**Re: ODOARDI – Vacant Lot
22 Nethermont Ave. – New House Construction
Tax ID: Section 122.16 – Block 4 – Lot 7**

This letter accompanies a revision to the plans, in response to the draft resolution received from the Planning Board Staff and Town Consulting Engineer.

Site Plan and Tree Removal Permit Approvals for

Odoardi [19-039]

ELEVATION VIEWS AND BUILDING HEIGHT PLAN
22 NETHERMONT AVE

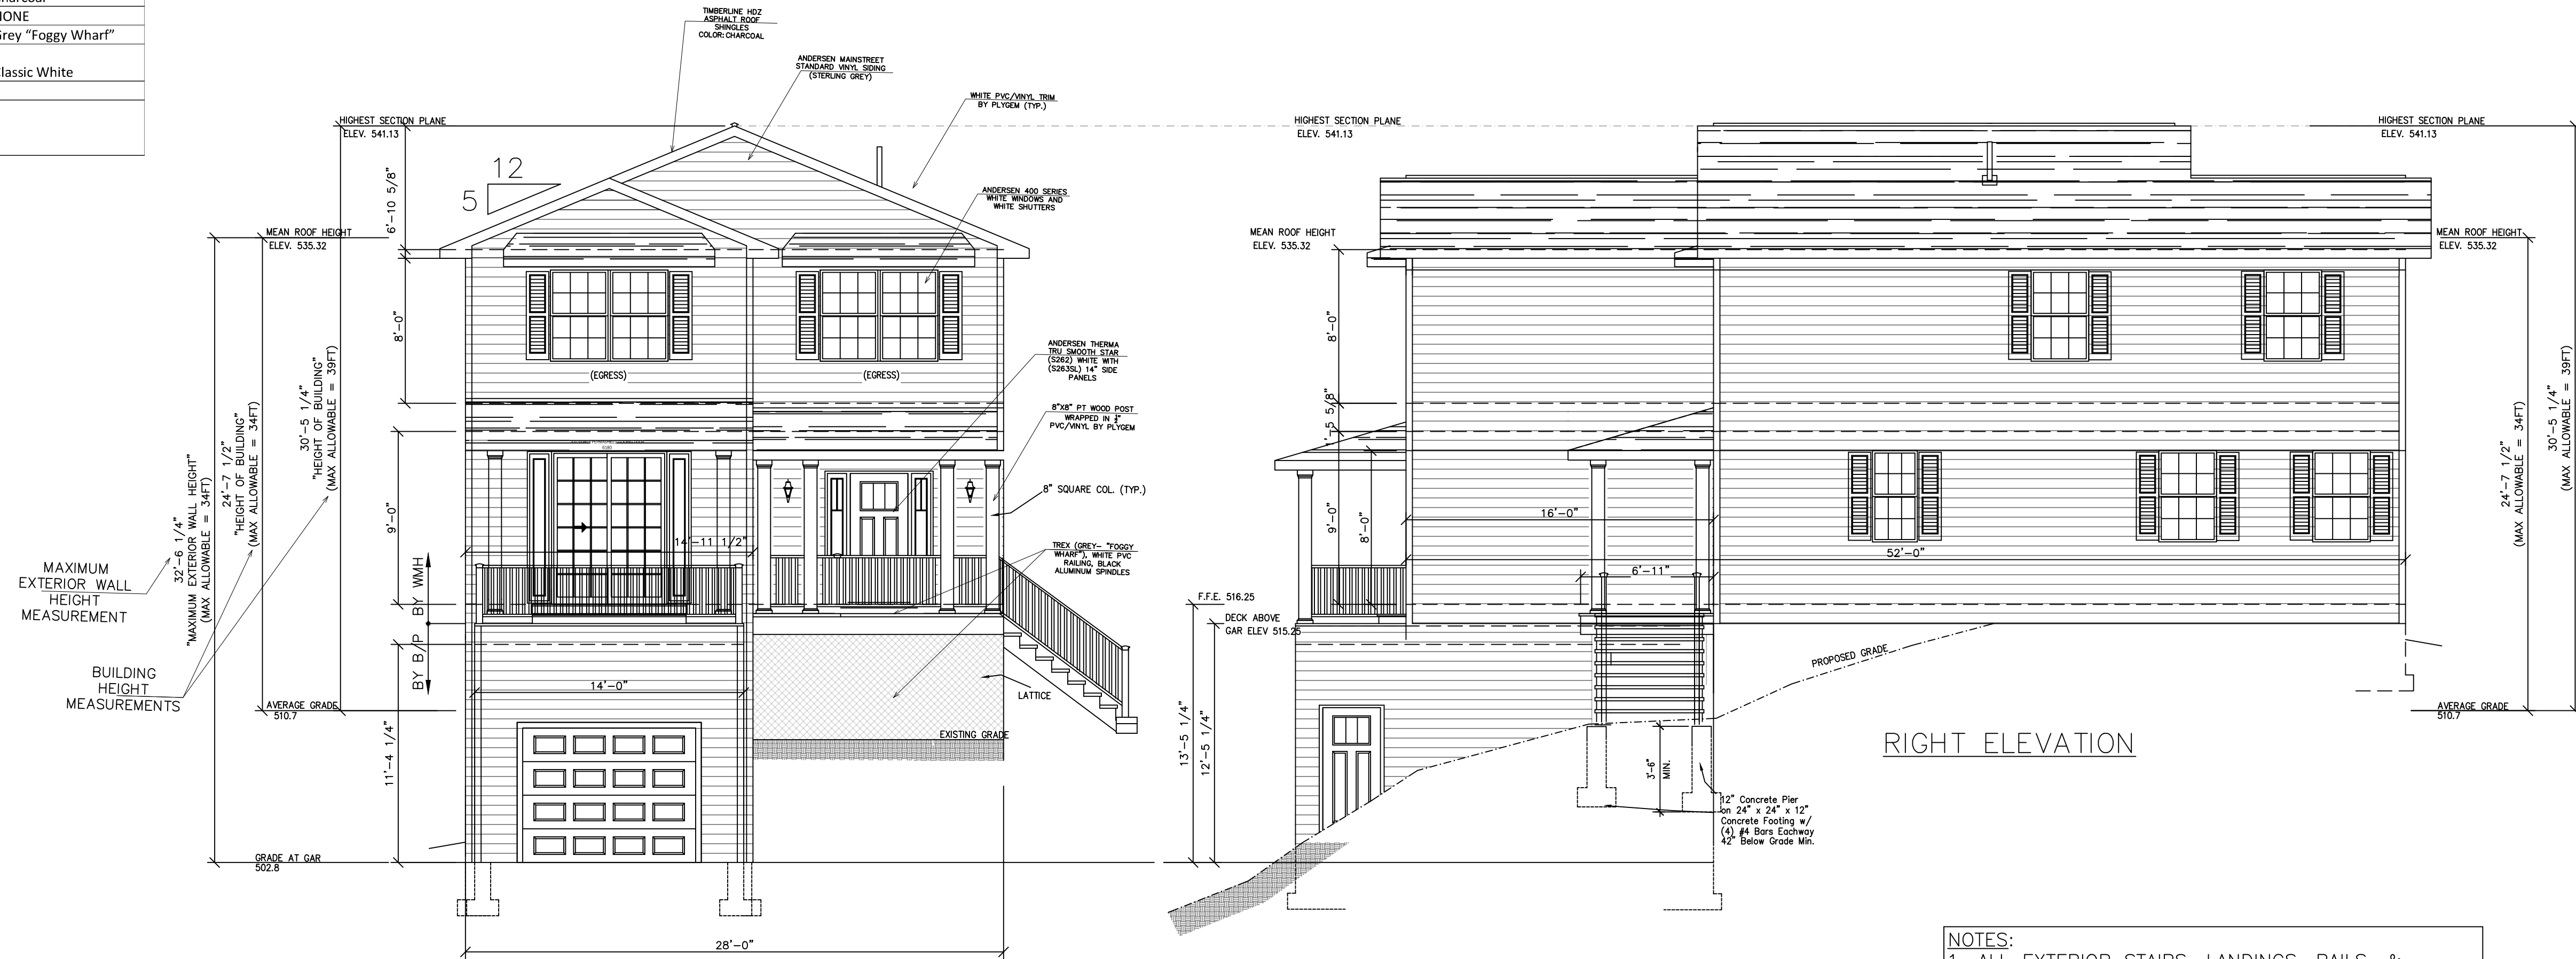
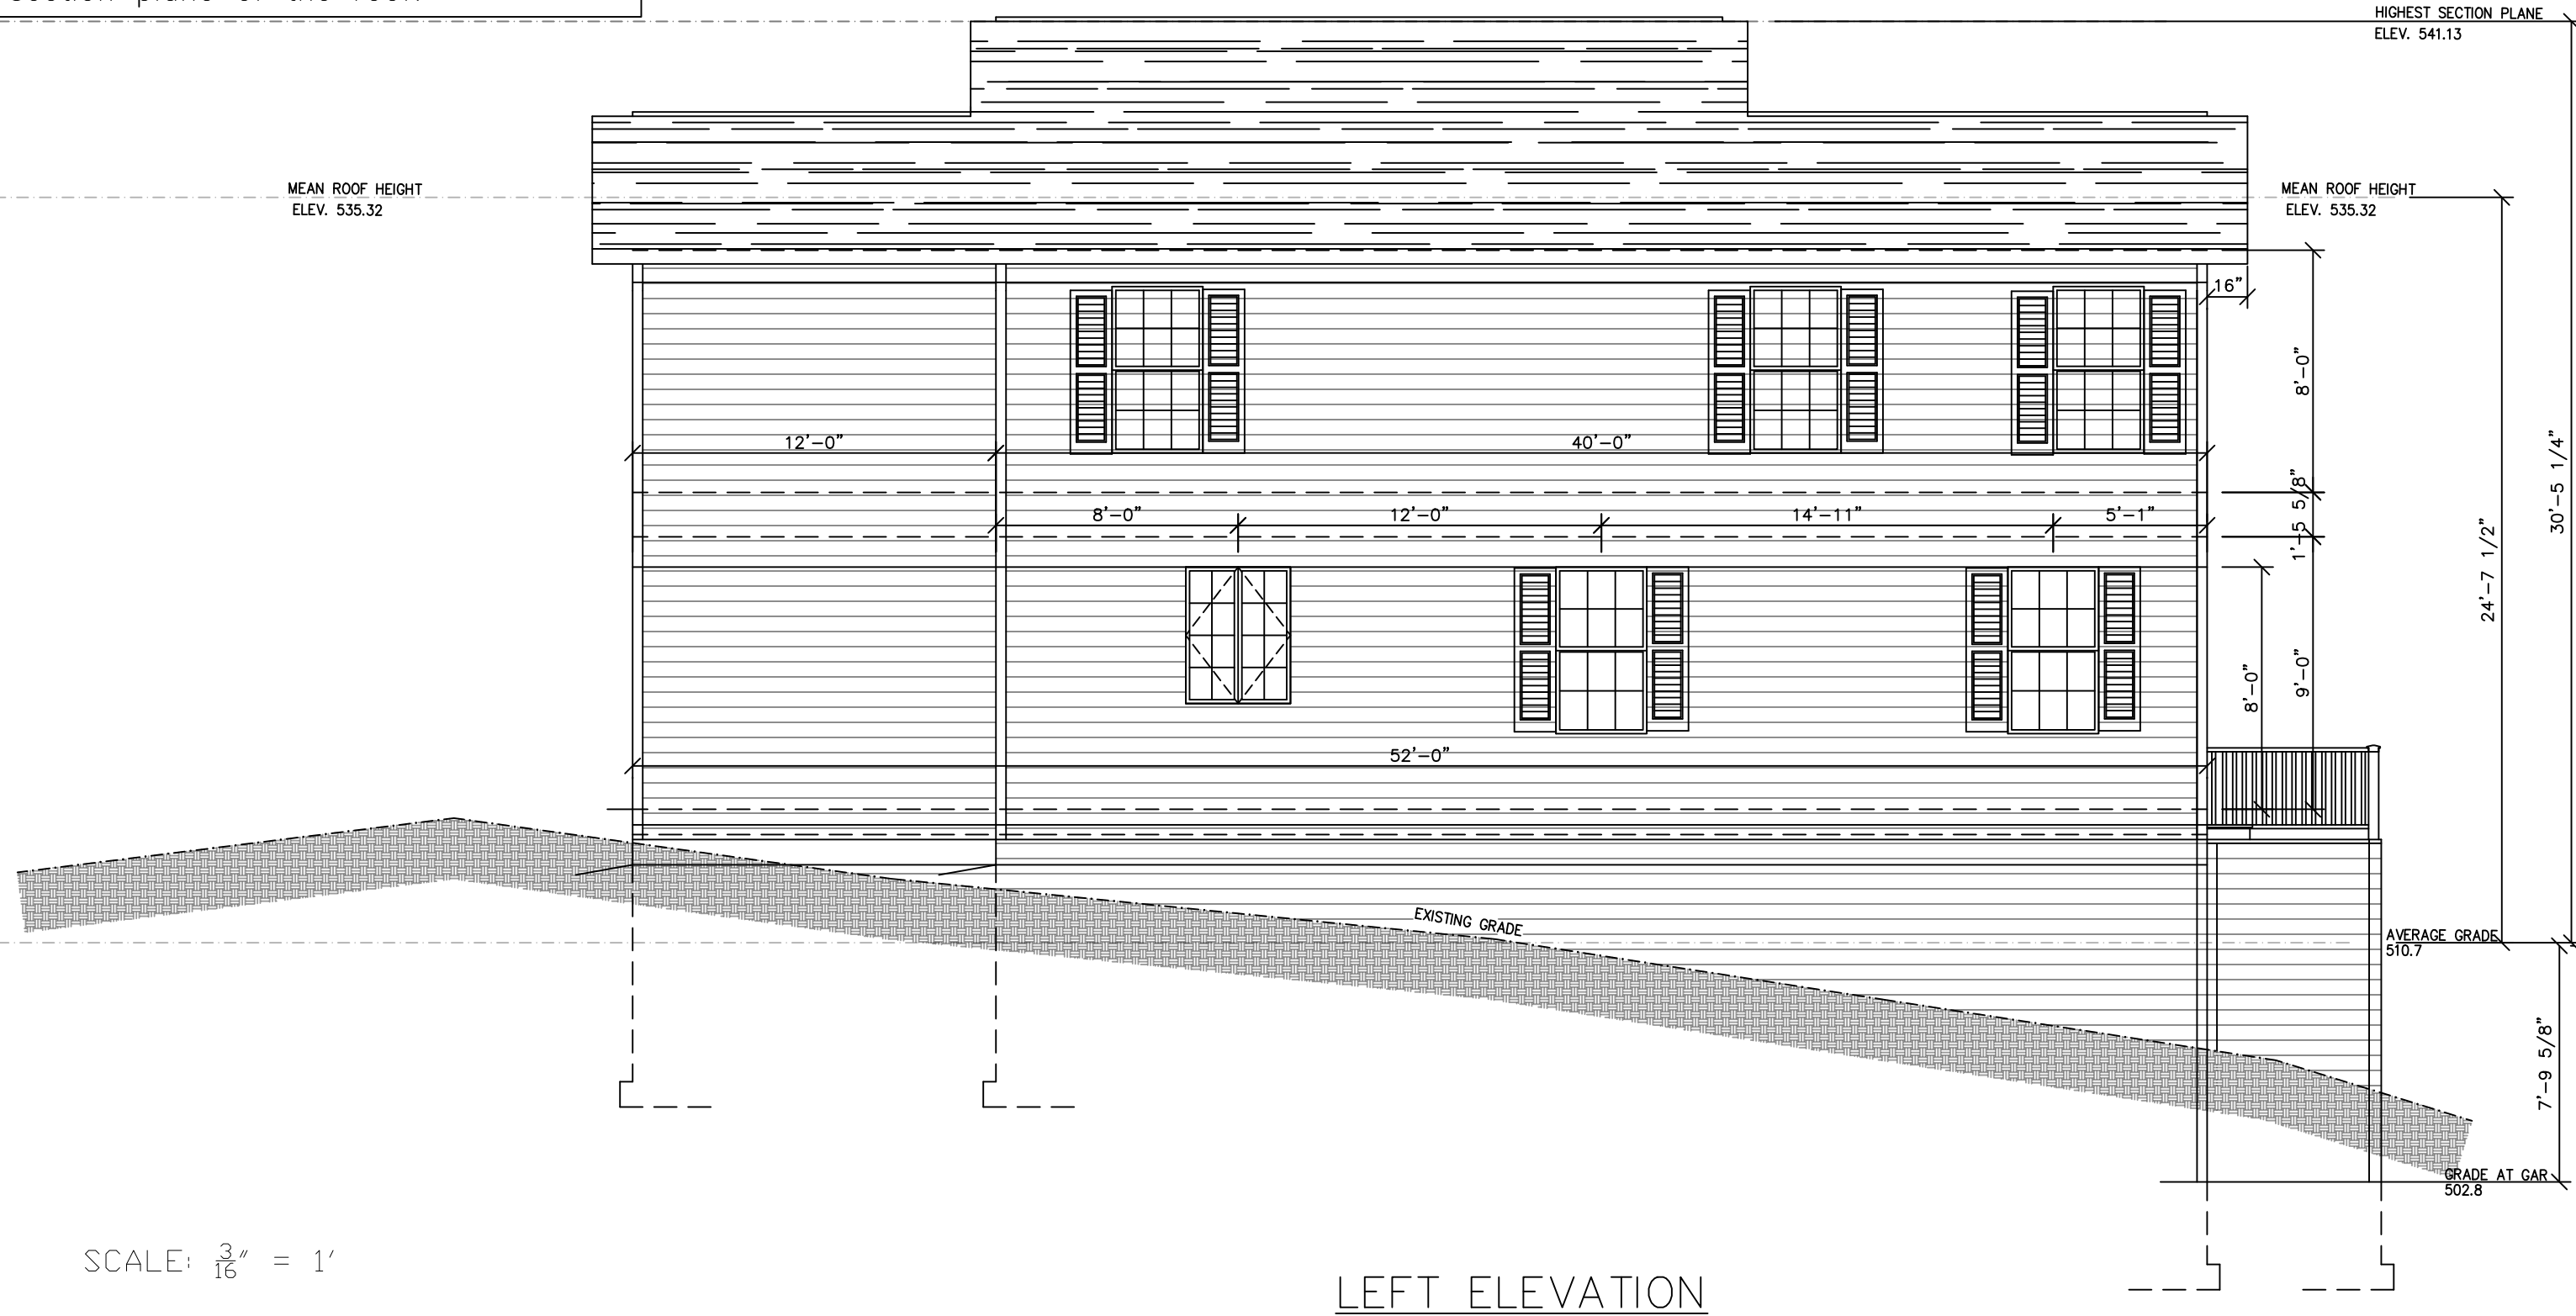
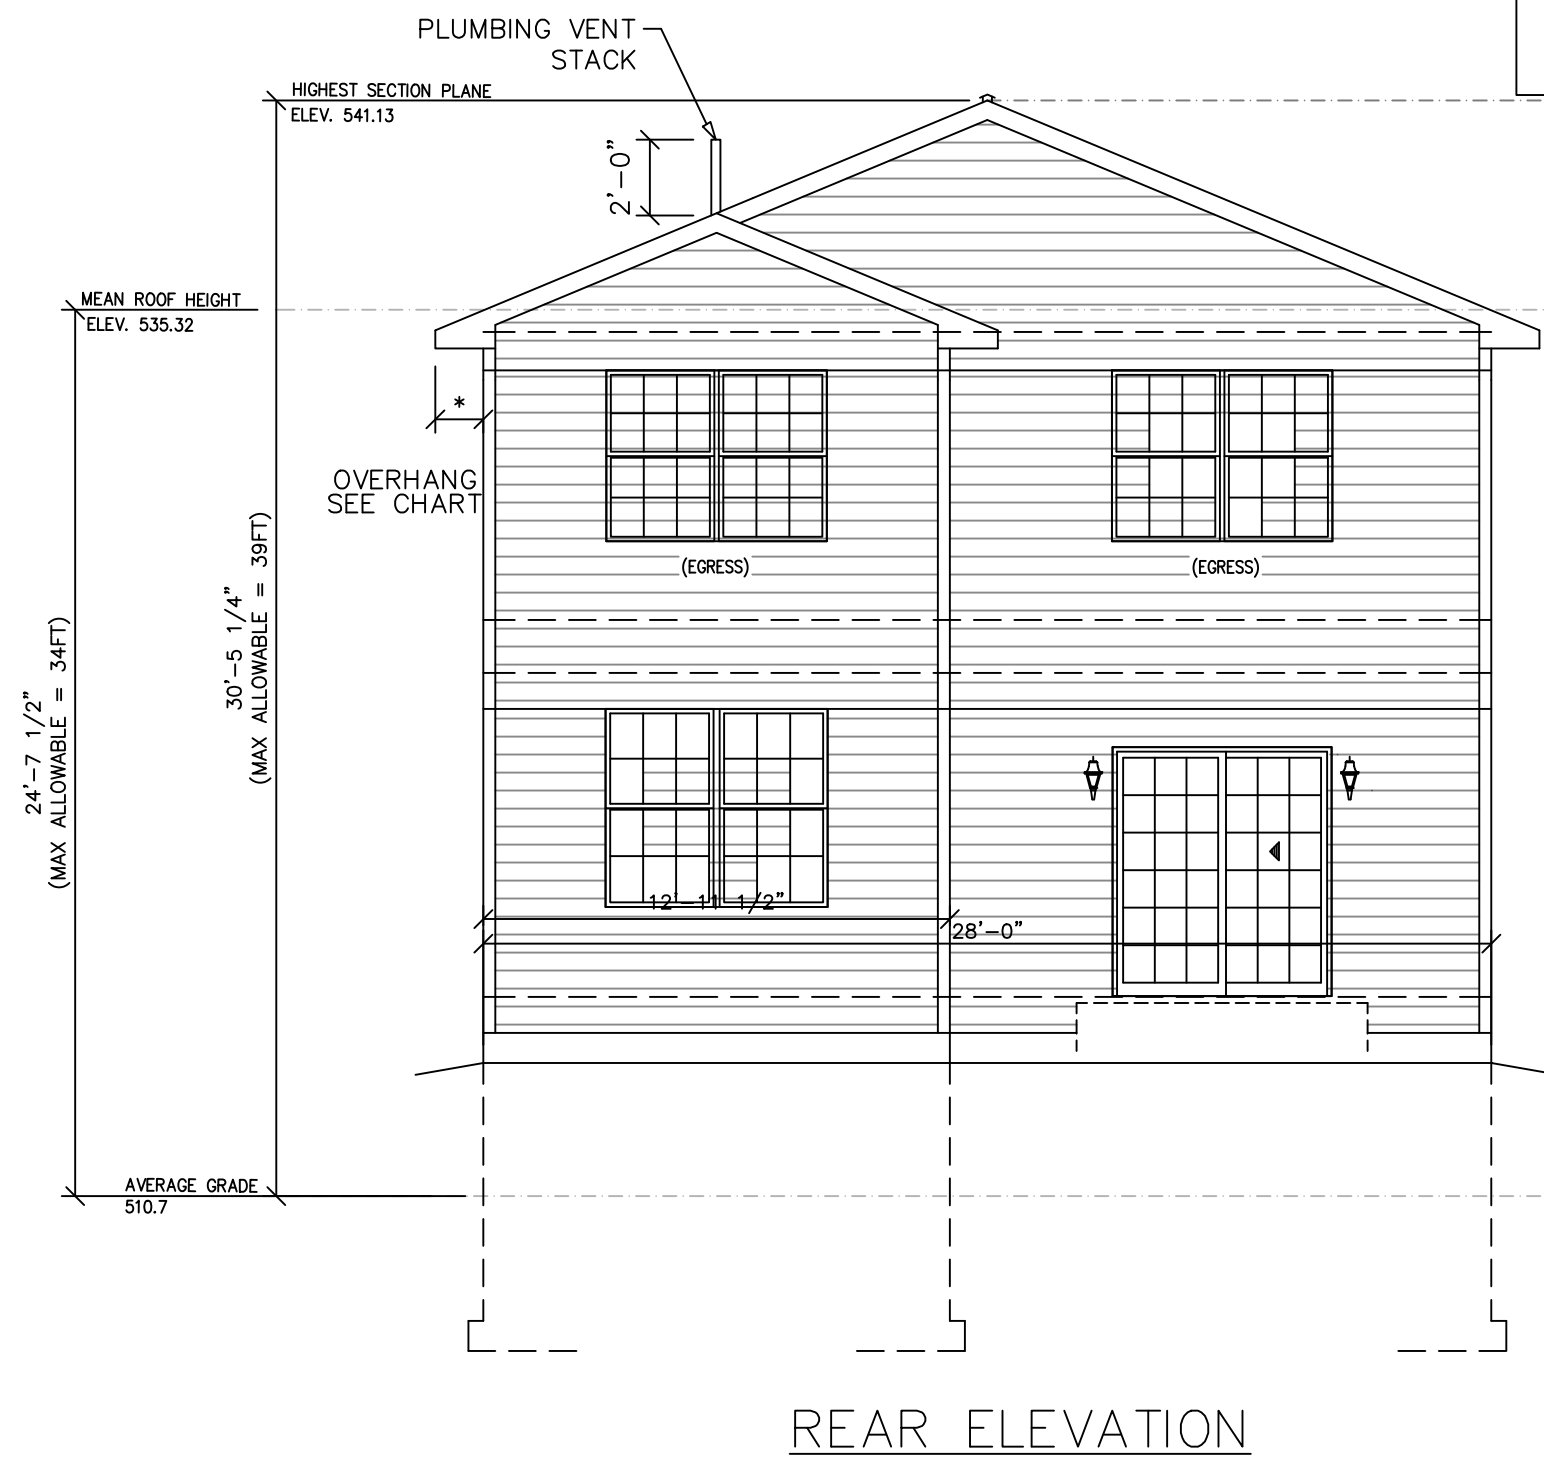
- _____ 11. The Applicant shall provide a maximum exterior wall height analysis to the satisfaction of the Planning Department (34' max). Plan A-002 is not correct. Maximum exterior wall should also be depicted on the front elevation. According to the elevation it should be measured from elevation 502.1 (grade at garage) to the roof midpoint. This would appear to result in a maximum exterior wall height in excess of the 34 foot maximum. In addition, the left elevation max exterior wall height measurement is from elevation 505, this does not appear to be

correct as the front elevation has the garage at 502.1, not 505. The elevations need to be coordinated.

See Building Height and Wall Height Analysis Revised on sheets A-001 and A-002
